TECHNICAL BULLETIN

[Issue No.] FA-A-0106

[Title] Programmable controller stop due to WDT error caused by incorrect Ethernet network configuration

[Relevant Models] Q03UDECPU, Q04UDEHCPU, Q06UDEHCPU, Q10UDEHCPU, Q13UDEHCPU, Q20UDEHCPU, Q26UDEHCPU, Q50UDEHCPU,

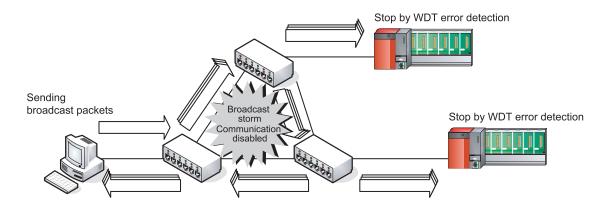
If an Ethernet network is configured into a loop as shown below, broadcast packets are accumulated in the band, and the communication is disabled. Therefore, do not configure the Ethernet network into a loop.

If a loop is formed as shown in the figure, broadcast packets are passed to all ports and continue to travel through the system. As a result, the packets are accumulated in the band, and the communication is disabled (referred to as a broadcast storm). The broadcast packets are frequently sent from personal computers as well as sent from the programmable controller. Therefore, configuring an Ethernet network into a loop will cause a broadcast storm, resulting in communication failure.
